**Economic Commission for Europe****Inland Transport Committee****World Forum for Harmonization of Vehicle Regulations****Working Party on Lighting and Light-Signalling****Ninety-fourth session**

**Device UN Regulations:****UN Regulation No. 150 (Retro-Reflective Devices)****Proposal for a Supplement to the 01 series of amendments to  
UN Regulation No. 150****Submitted by the experts from The International Automotive Lighting  
and Light-Signalling Expert Group\***

## I. Proposal for a Supplement to the 01 series of amendments to UN Regulation No. 150

Figure I  
Approval markings proportions

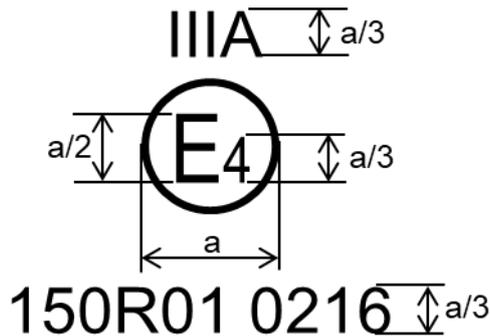
Paragraph 3.3.1.3., amend to read:

“3.3.1.3. With regard to the size of the approval marking the value for "a" is defined in Table 1.

Examples of the arrangement of the markings are shown in Annex 10. ”

### “ Figure A10-I: Marking examples for single devices

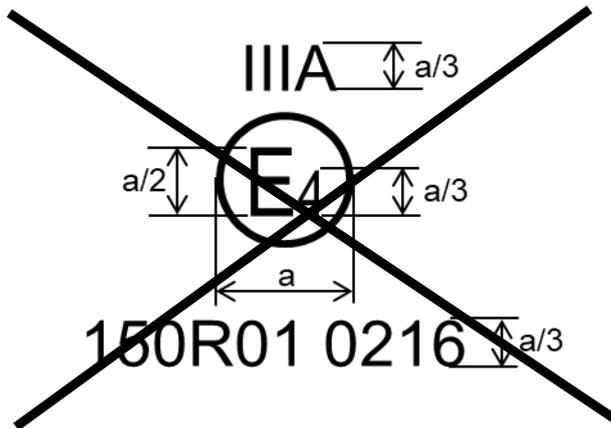
Figure A10-1, amend to read:

~~For a = see Table 1~~

*Note:* The above approval number **and the group of symbols indicating the class** must be placed close to, but in any position in relation to, the circle surrounding the letter "E". The digits constituting the approval number must face the same way as the "E". ~~The group of symbols indicating the class must be diametrically opposite the approval number.~~ The Type Approval Authorities shall avoid using approval numbers IA, IB, IIIA, IIIB and IVA which might be confused with the class symbols IA, IB, IIIA, IIIB and IVA.
